Audio	Quick Service Manual	Ref.No. : MESA0303PM17a
	Model : SA-PM17,PM27,PM47	Date : 31.March. 2004(Revised)
		Cases reported (country)
		Japan
Special customer inquiry <input type="checkbox"/>	Parts shortage solution <input type="checkbox"/>	Fregunce level
Improve by External factor <input type="checkbox"/>	Product improvement <input checked="" type="checkbox"/>	High <u>Low</u> A few One

Subject : CD Tray does not open/Close (CR16 Mechanism)

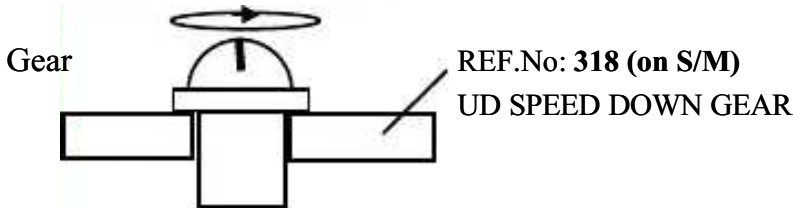
Remedy : 1) **Add** Screw to secure Gear in place. (Part No: XTBS26+8J)

do not overtighen SCREW.
